### **REMARKS**

The present Amendment is in response to the Examiner's Office Action (hereinafter referred to as "Office Action") mailed September 8, 2005. Claims 1-20 were pending at the time of the last examination. By this amendment Claims 7 and 18 are cancelled, Claims 1, 8, and 12 are amended, and new Claims 21 and 22 are added. Claims 1-6, 8-17, and 19-22 are now pending in view of the above amendments.

**Amendments to the Drawings:**

Fig. 1

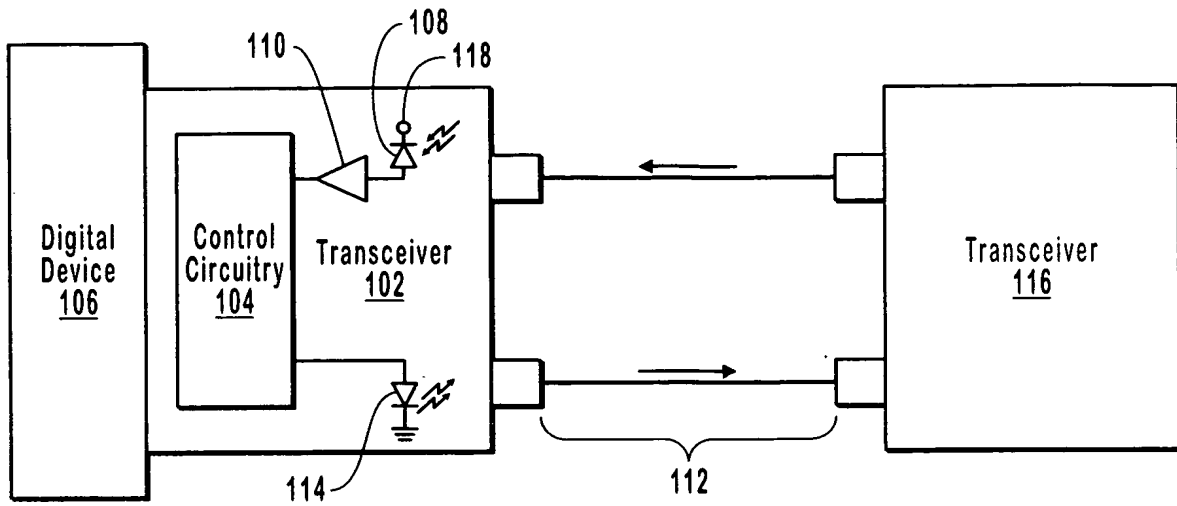
The Office Action in Section 1 objected to various drawings because block diagrams 104, 106, 116 in Figure 1, 232 in Figure 2, and 614 in Figure 6B were not labeled. Applicants submit new Figures 1, 2, and 6 which label the designated block diagrams. Also enclosed is a redlined copy of Figures 1, 2, and 6 showing the change being made.

Fig. 5

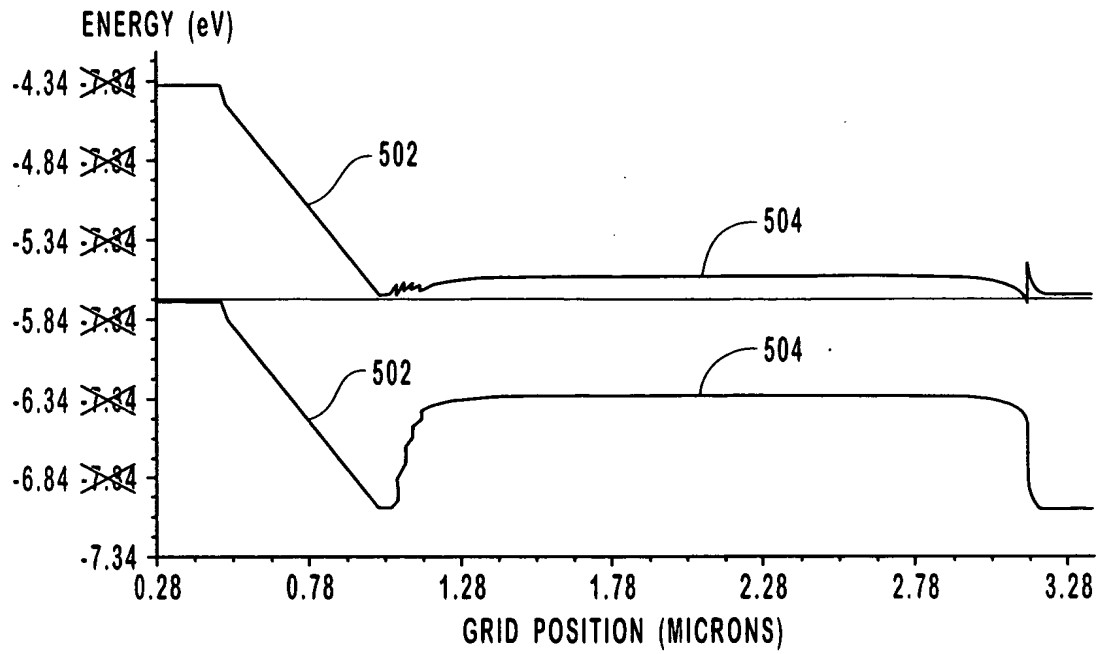
In addition, Section 1 of the Office Action objected to the vertical labeling of Figure 5. In response, Applicants have amended the vertical labeling so that the numbers are not the same. Applicants submit new Figure 5 with the amended vertical labeling. Also enclosed is a redlined copy of Figure 5 showing the change being made. Applicants note that no new matter has been added as the vertical labeling has been amended to match the vertical labeling of Figure 4 of U.S. Provisional Application No. 60/423,175, which was incorporated by reference by the pending application. Withdrawal of this ground of rejection is respectfully requested.

Fig. 6B

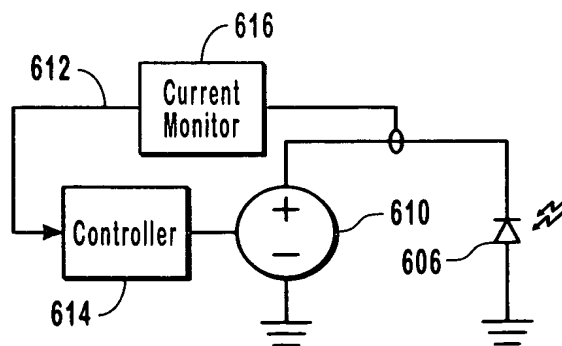
Applicants have further amended paragraph 46 to match amended Figure 6. Specifically the current monitor that was already discussed was given a label of "616" as in the amended
